DEVELOPMENT REVIEW BOARD
SUPPLEMENTAL SUBMITTAL

PROJECT NO. PR-2019-002277
Application No. SI-2019-00246

SUBMITTAL DESCRIPTION: DRB Site Plan Resubmittal. See included letter for more information.

RE: Adagio Apartments (Tract A)
PR-2019-002277

SHEET NUMBER: C-100

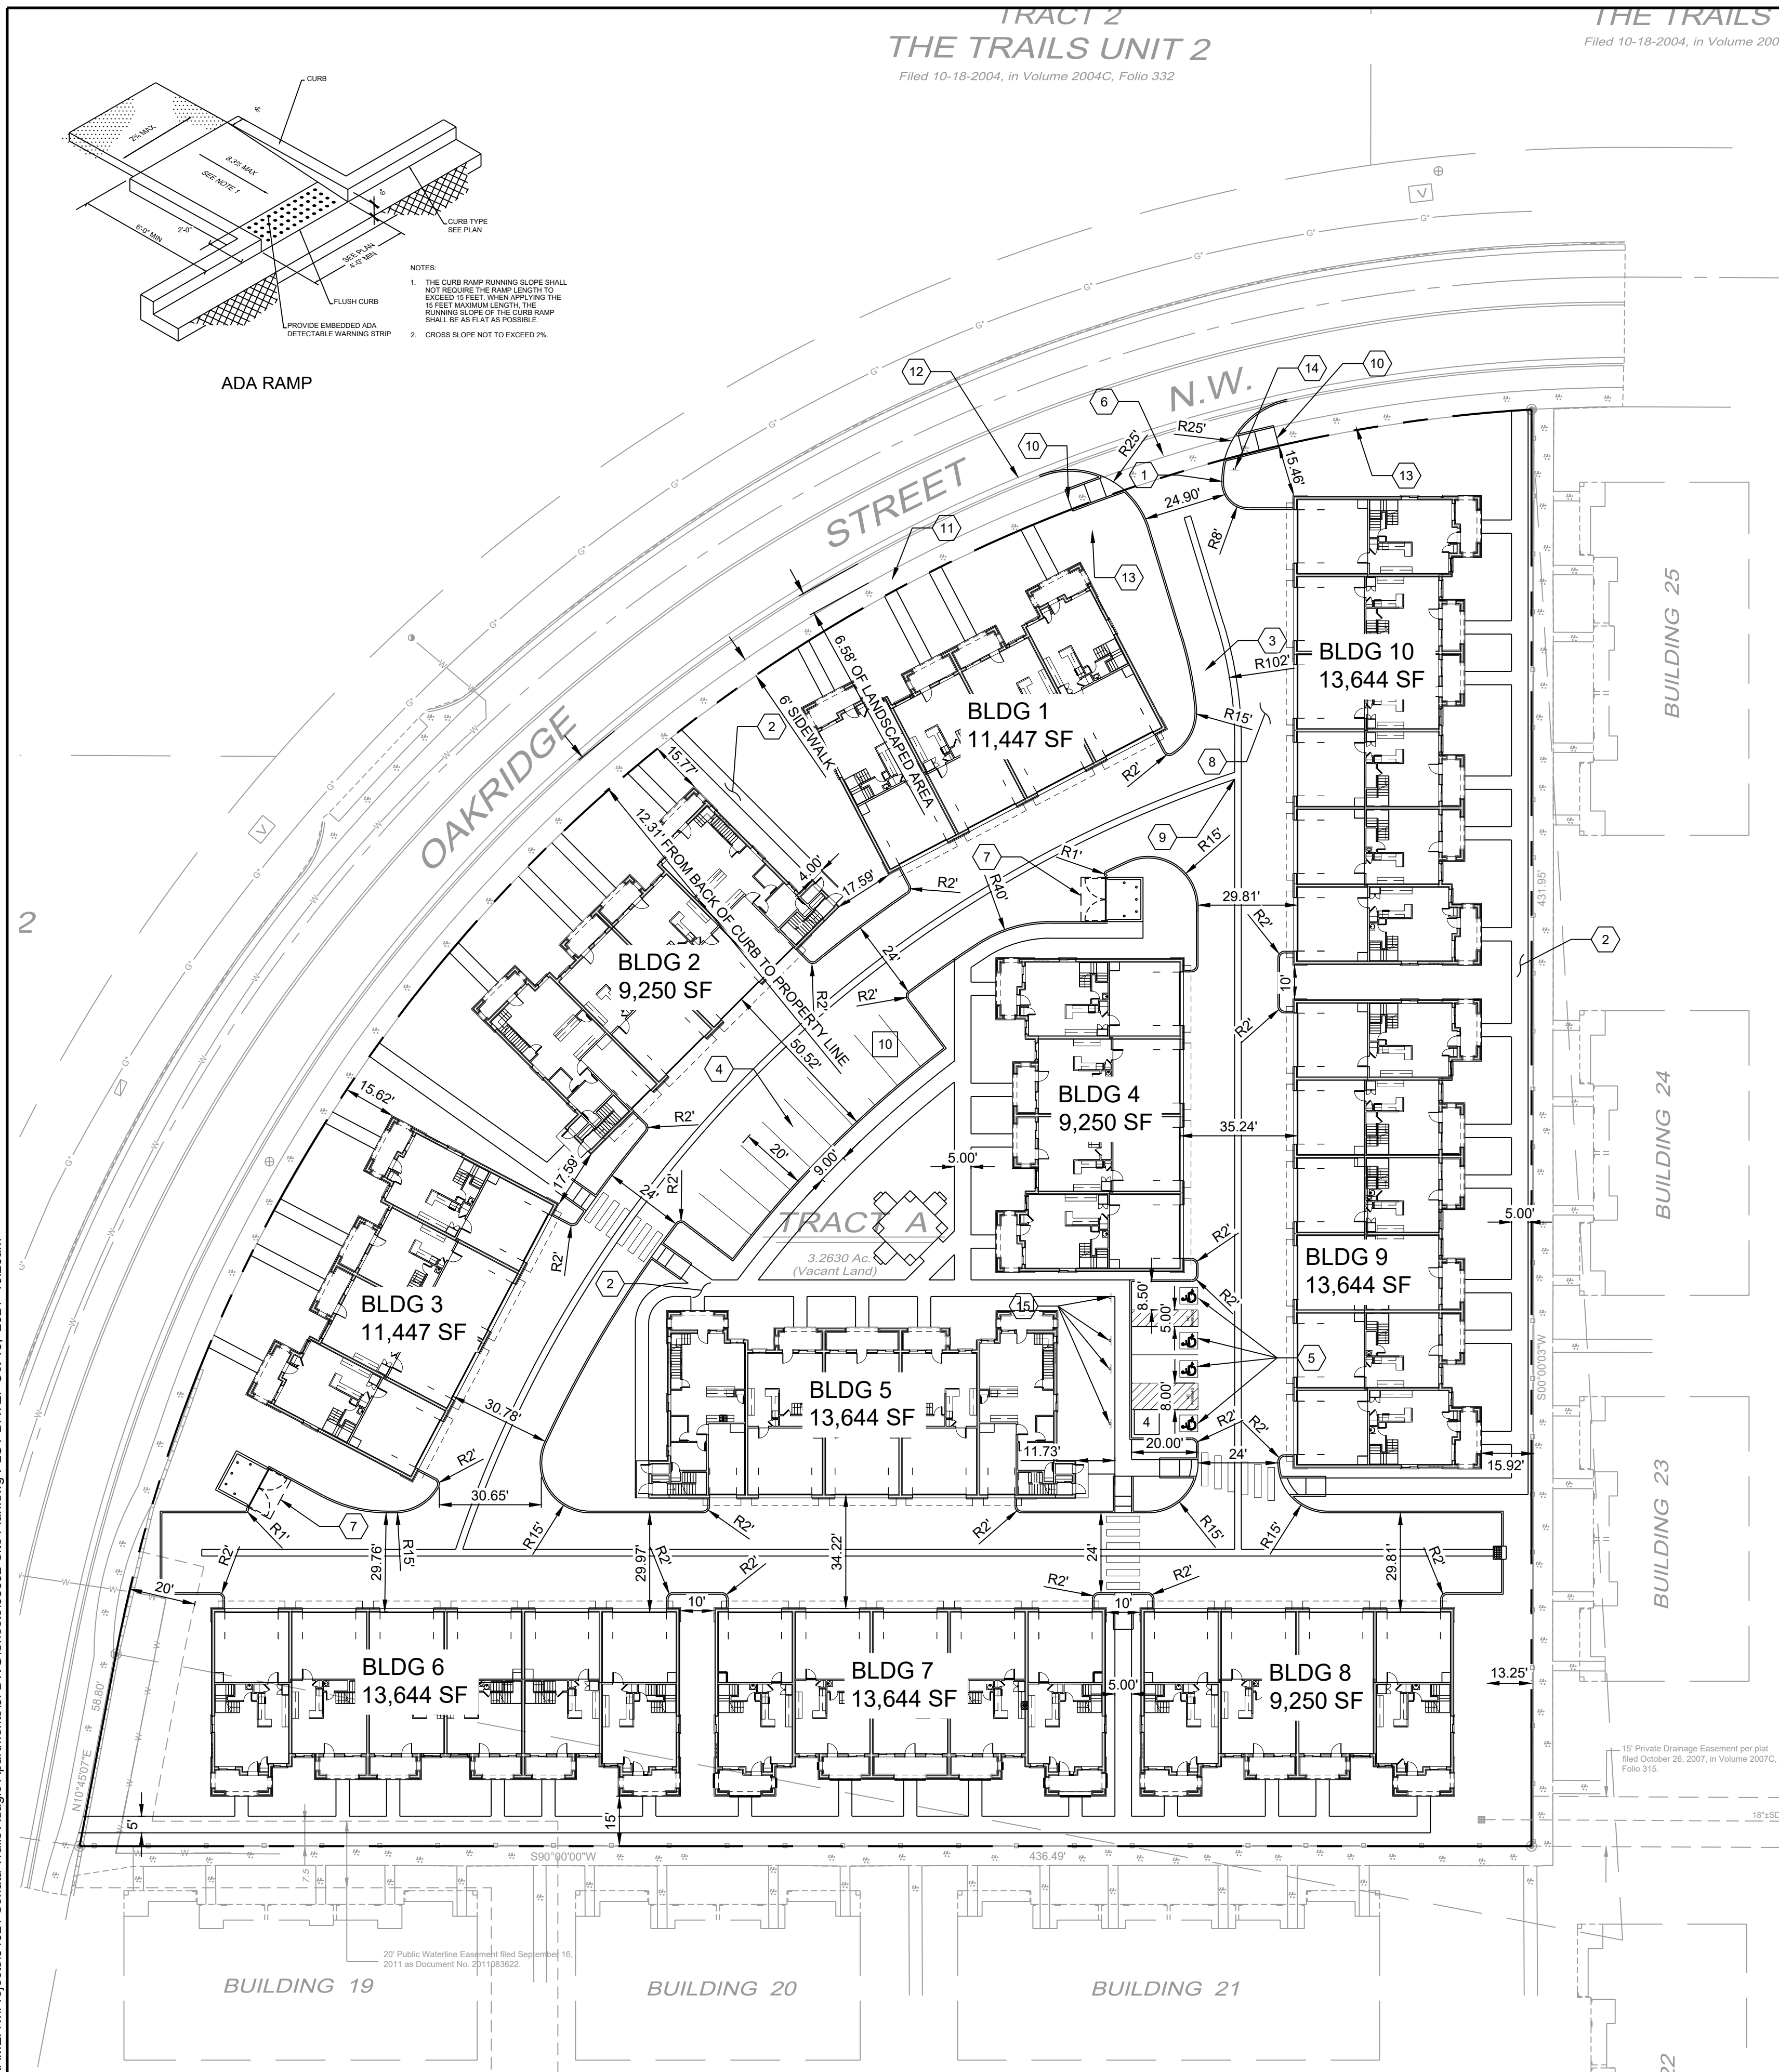
Since our last DRB hearing, some minor aspects of this project have changed. The buildings have been modified to accommodate ICF construction as opposed to wood frame. The elevations and rendering included have been updated to reflect this. This also caused minor modifications to the site layout, which are reflected on the updated Site Plan attached. In turn, the site grading, drainage, utility, and landscape plans have been revised to reflect the latest building footprints. It is also worth noting that the driveway has been slightly realigned to match the new entrance for Volcano Mesa (Tract 2) across the street.

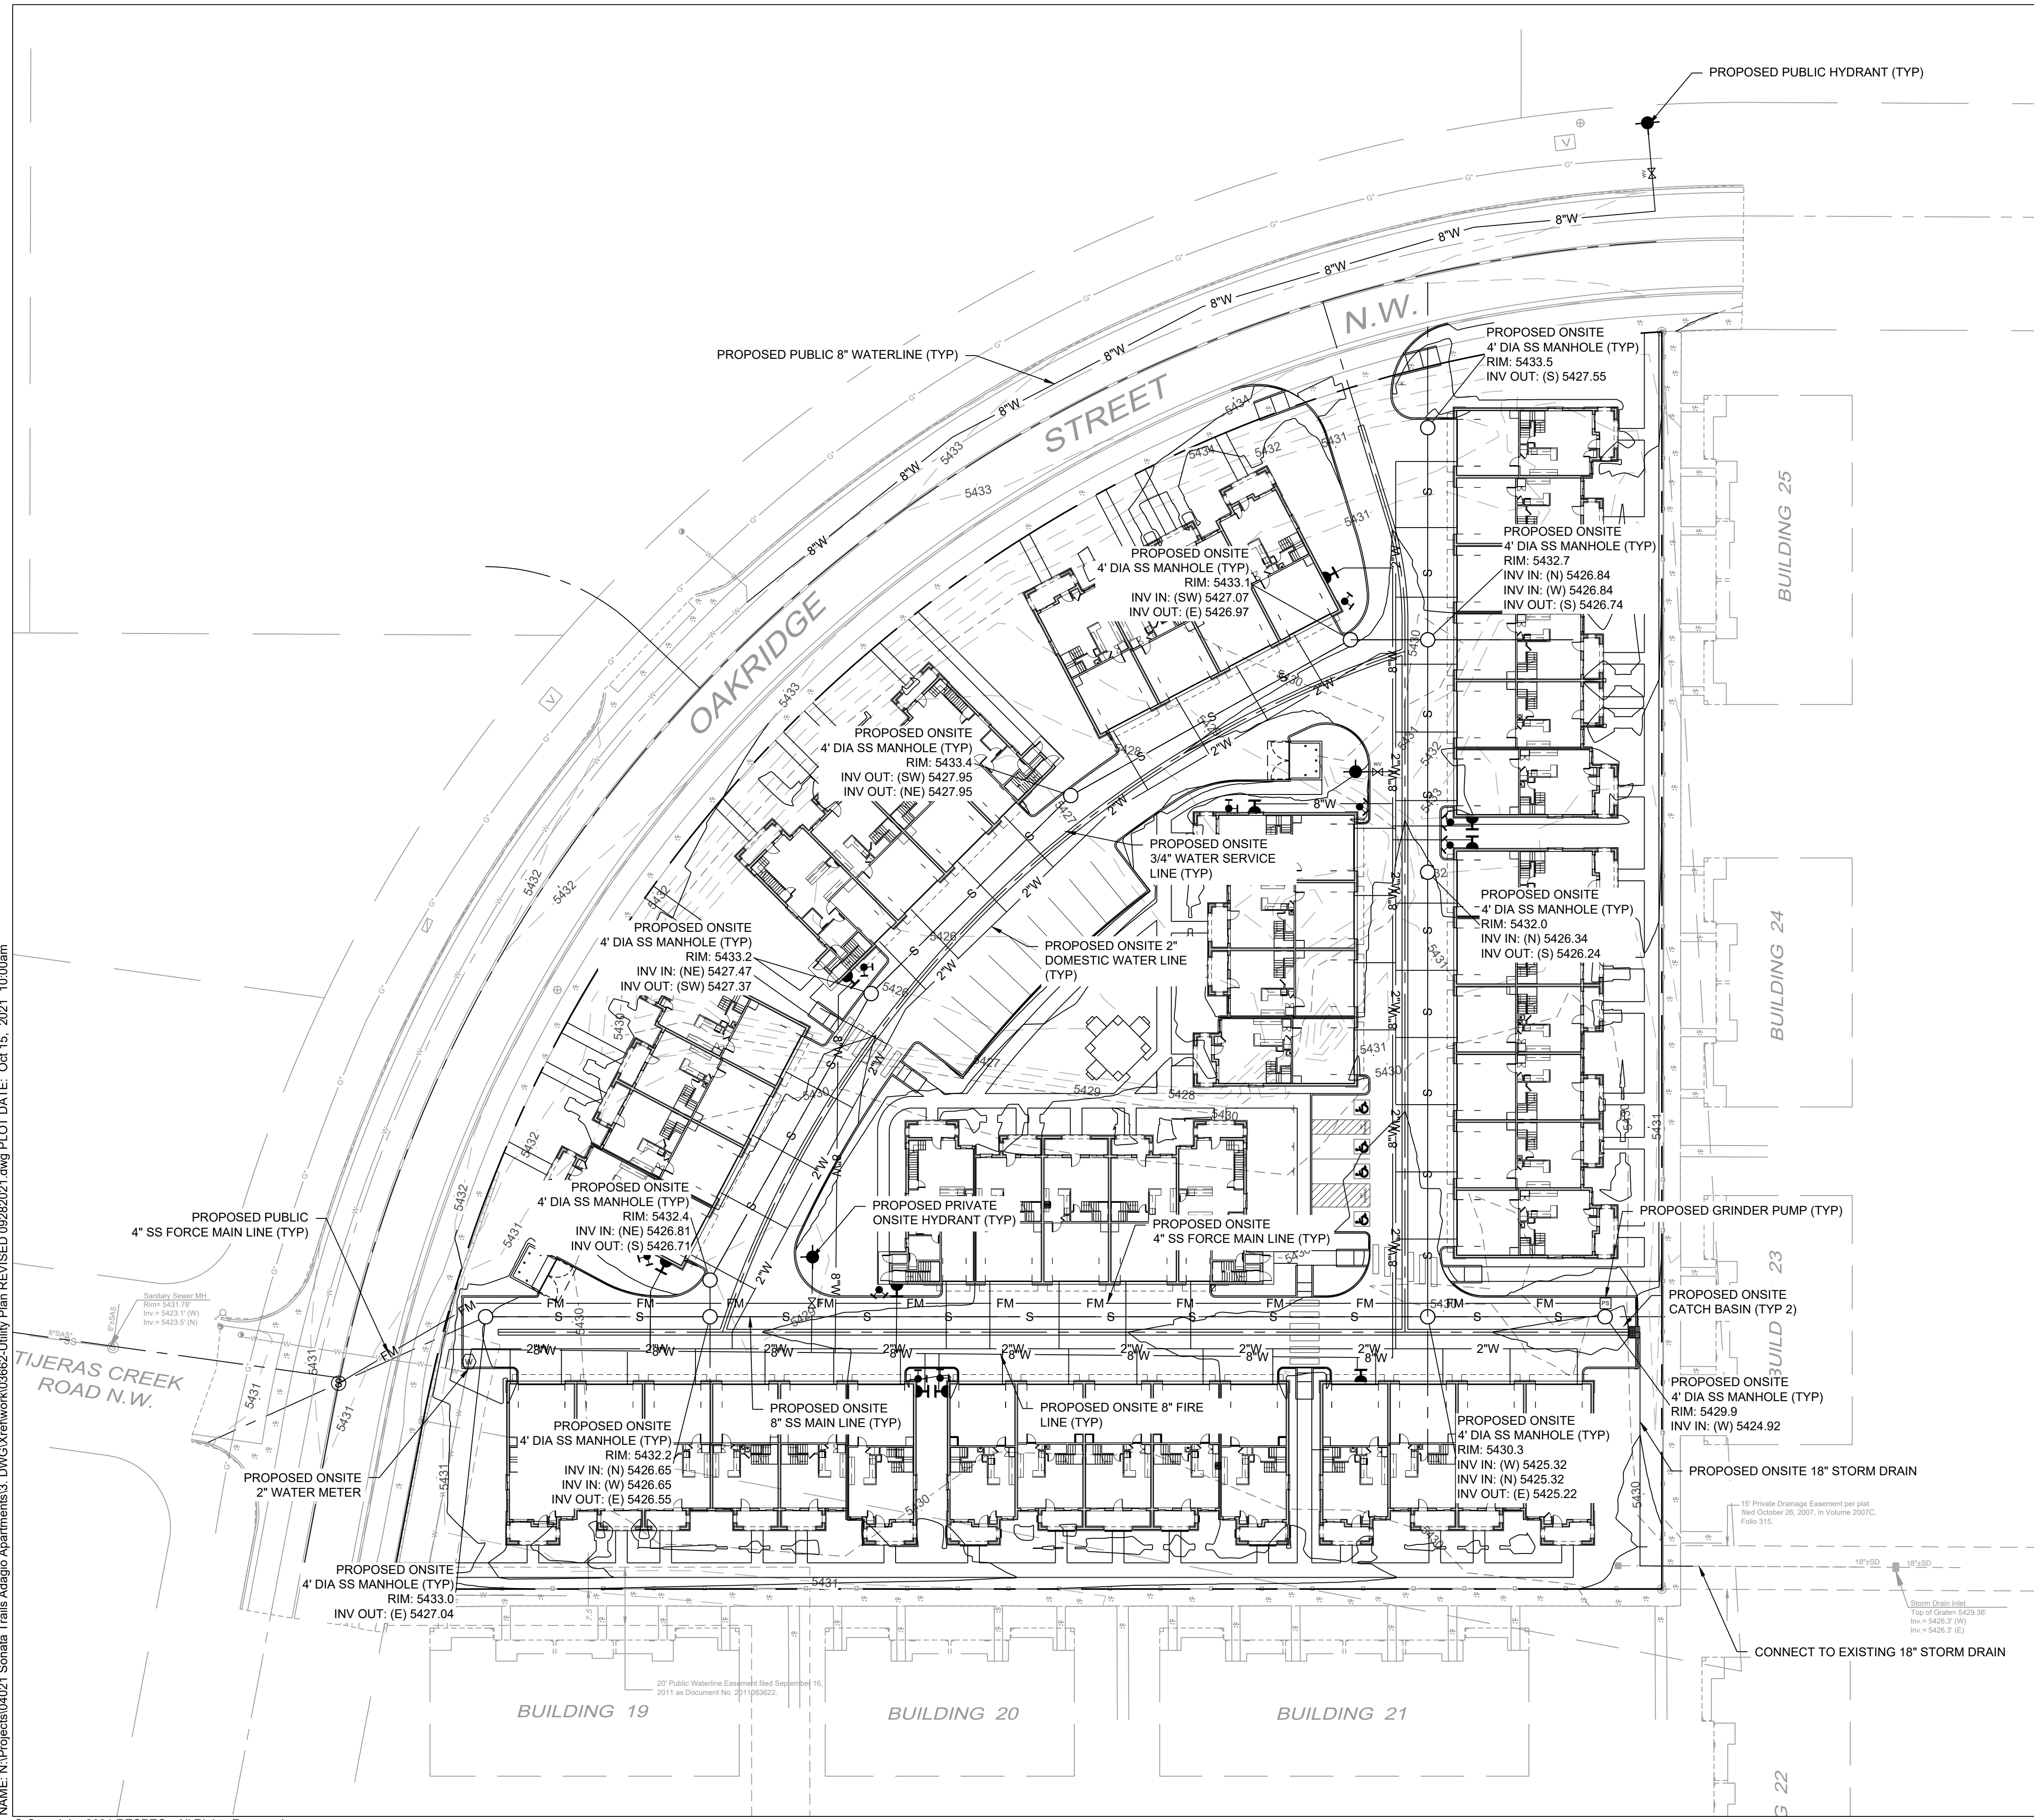
The proposed sewer infrastructure for this project has also changed. For the private utilities, instead of a grinder pump to serve each individual building, we have consolidated to a single lift station located at the southeast corner of the site. The Utility Plan included reflects this change. There was also a public sewer main previously required to be extended within Oak Ridge. It is my understanding that this requirement is no longer applicable since a sewer stub is being provided to Tract 3 with the Volcano Mesa project across the street. The Utility Plan and Infrastructure List has been revised to remove the public sewer main extension.
